Application for Variation of an Environmental Permit

C1. Name of the Current Environmental Permit Holder :  
CLP Power Hong Kong Limited  
C2. Application No. of the Current Environmental Permit : FEP-01/341/2009/A  
C3. The Current Environmental Permit was Issued in : month / year  
04 / 2021

# Hong Kong Offshore Wind Farm in Southeastern Waters

Environmental Review Report for Proposed Cable Route

Figure A

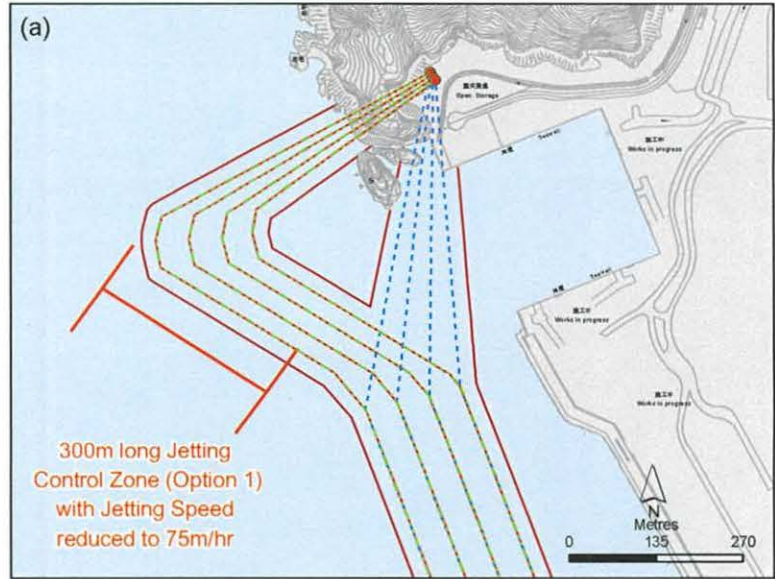
Condition	D1 Condition(s) in the Current Environmental Permit:	D2 Proposed Variation(s):	D3 Reason for Variation(s):
Figure 1	Location Plan	To be replaced with <b>Figure A</b> .	Following the proposed changes in scale and scope described below.
Condition 2.4	The Permit Holder shall submit to the Director for approval, at least six months before the commencement of construction of the Project, three hard copies and one electronic copy of the final layout of the wind farm turbines with demonstrations that the final layout, among the possible alternative layouts, has minimized the footprint of the project and maximized the distance of the turbines from Ninepin Group and Ung Kong Group.	The Permit Holder shall submit to the Director for approval, at least six months before the commencement of construction of the Project, three hard copies and one electronic copy of the final layout of the wind farm turbines, <u>cable alignment and location of cable landing site</u> with demonstrations that the final layout, among the possible alternative layouts, has minimized the footprint of the project and maximized the distance of the turbines from Ninepin Group and Ung Kong Group.	The final wind farm layout; cable alignment and cable landing site shall be confirmed by the Project Proponent at detailed design stage prior to the commencement of construction of the Project.

Figure B

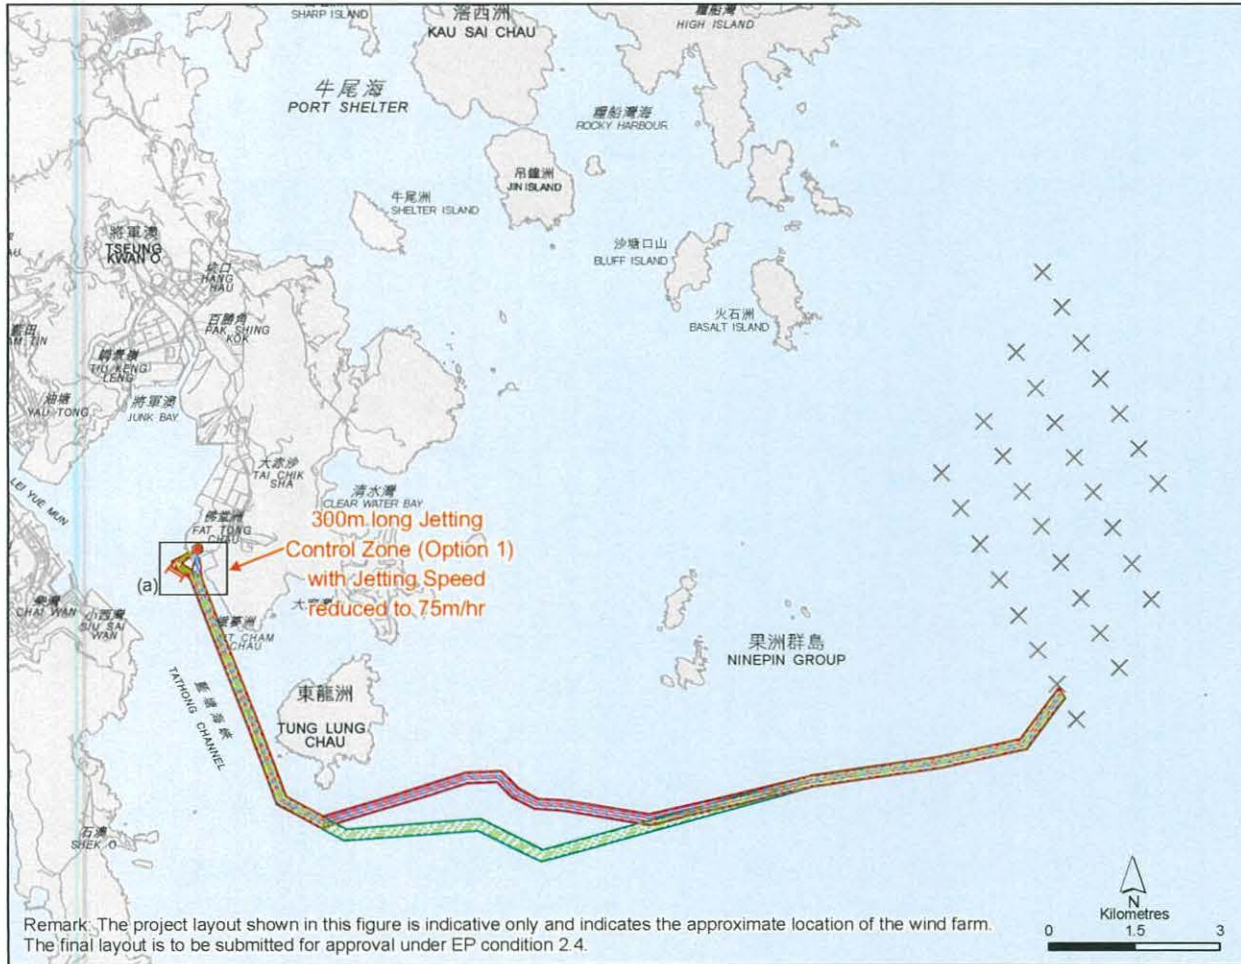
Condition 3.2 and Figure 3	Transmission power cables and collection power cables shall be installed by jetting only, with the exception of the section located at Junk Bay which may require dredging for anchor protection measures. The dredging zone is shown in Figure 3 of this Permit. Dredging can only be carried out with no more than two grab dredgers deployed and operated at the same time with a minimum separation of 100m at each dredging point. Total dredging rate should not exceed 6,300m <sup>3</sup> /day for two dredgers together. Closed grab dredgers shall be used and maintained to minimize spillage of sediment.	Transmission power cables and collection power cables shall be installed by jetting <u>and Horizontal Directional Drilling (HDD) only.</u> <del>with the exception of the section located at Junk Bay which may require dredging for anchor protection measures. The dredging zone is shown in Figure 3 of this Permit. Dredging can only be carried out with no more than two grab dredgers deployed and operated at the same time with a minimum separation of 100m at each dredging point. Total dredging rate should not exceed 6,300m<sup>3</sup>/day for two dredgers together. Closed grab dredgers shall be used and maintained to minimize spillage of sediment.</del>  Figure 3 to be deleted	Dredging works within Junk Bay is no longer required and cable system at Fat Tong Chau would be laid by HDD.  Figure 3 showing the dredging zone within Junk Bay is no longer required.

Figure C

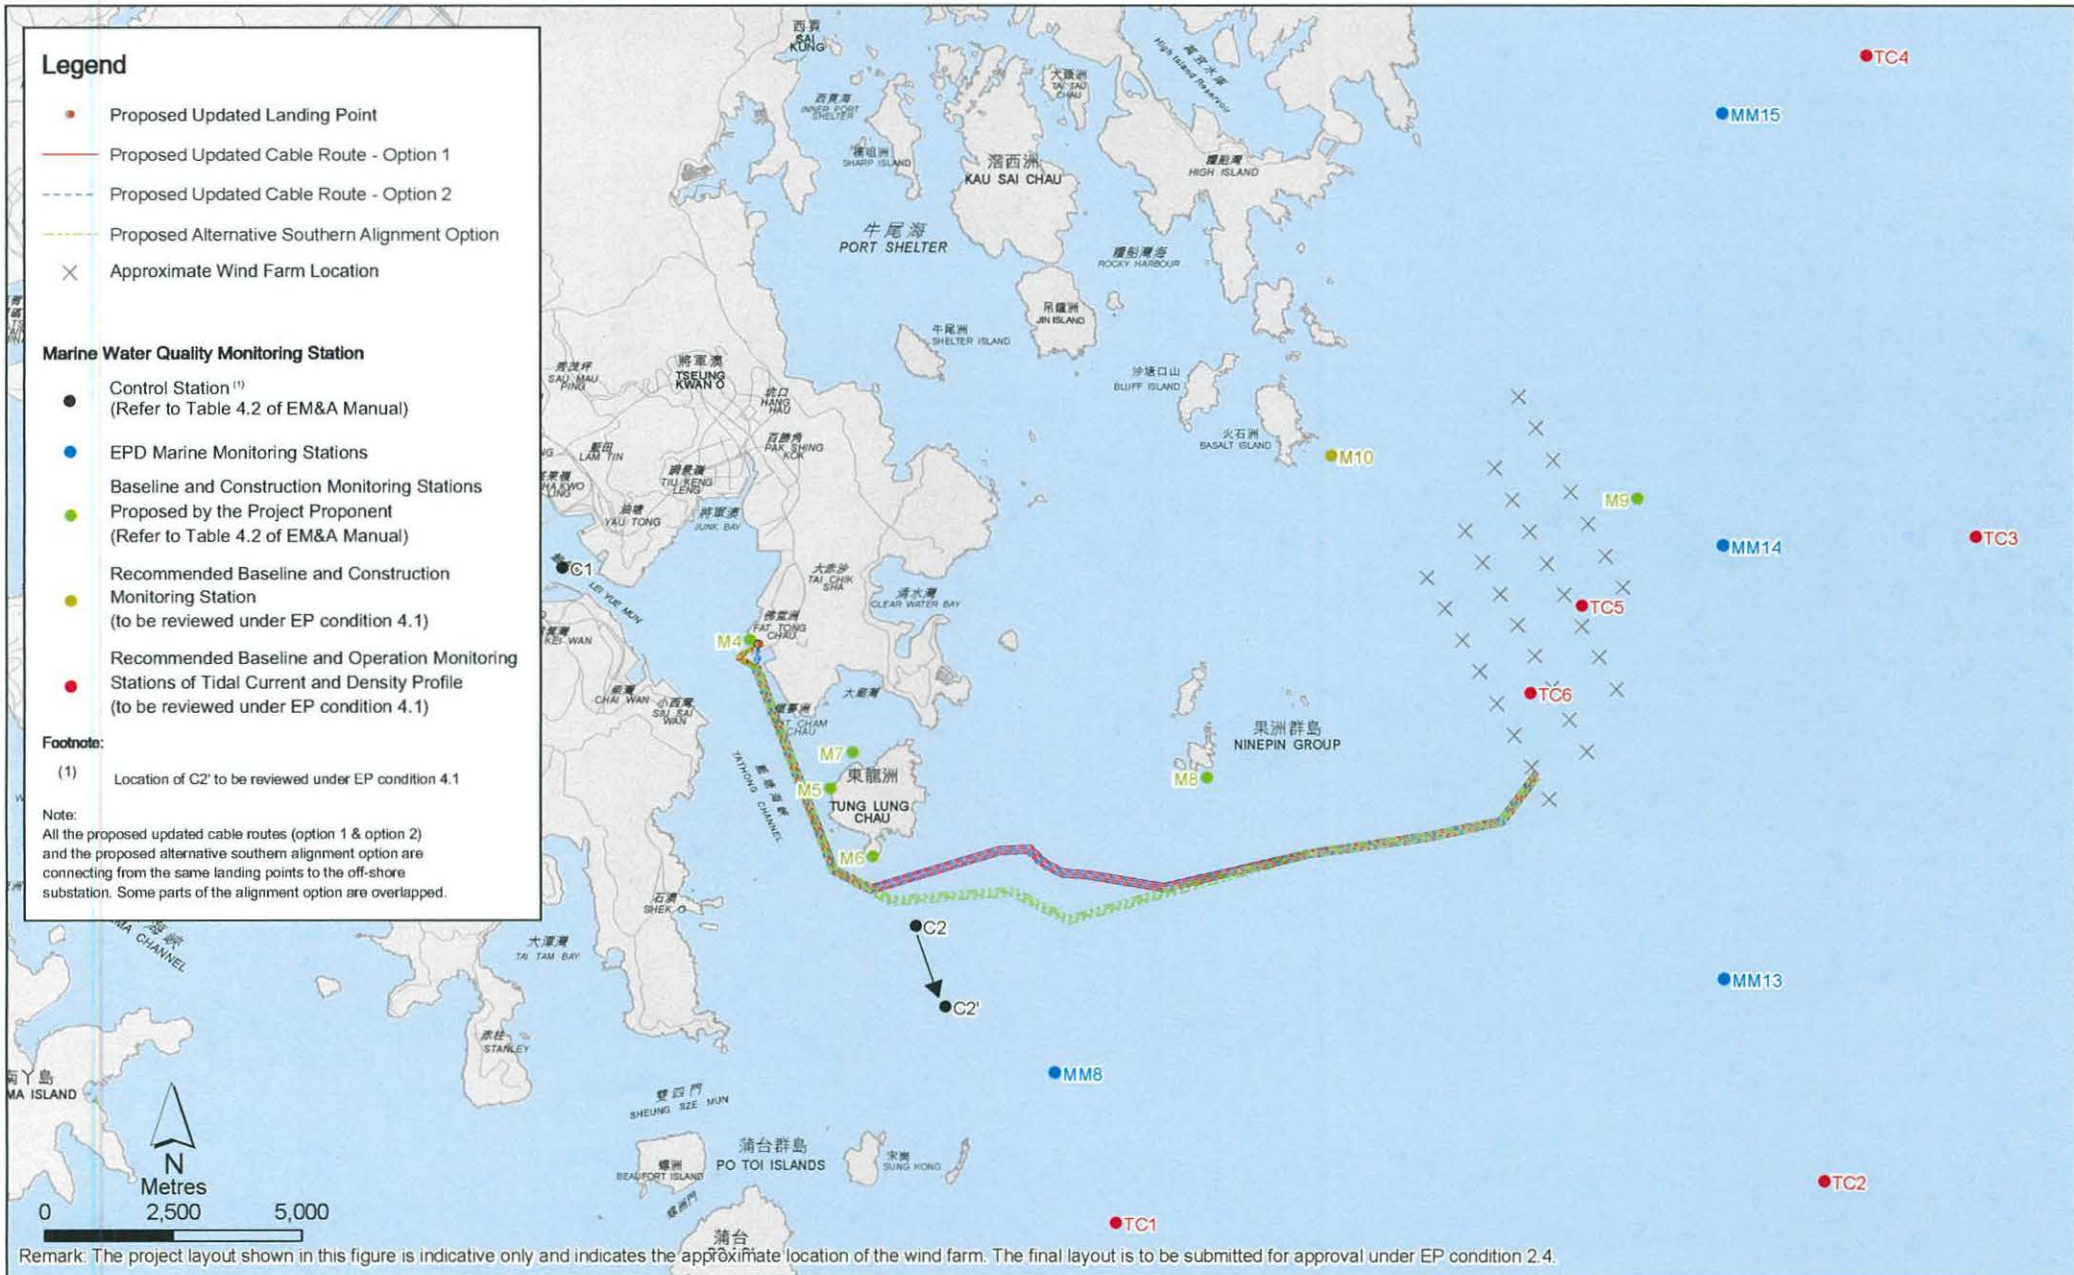
Condition	D1	D2	D3
	Condition(s) in the Current Environmental Permit:	Proposed Variation(s):	Reason for Variation(s):
-	-	<u>Proposed New Condition:</u> Submission of a monitoring proposal for AMO's agreement prior to the commencement of construction works.	The Fat Tong Chau SAI is located directly above HDD section of the proposed cable alignment.
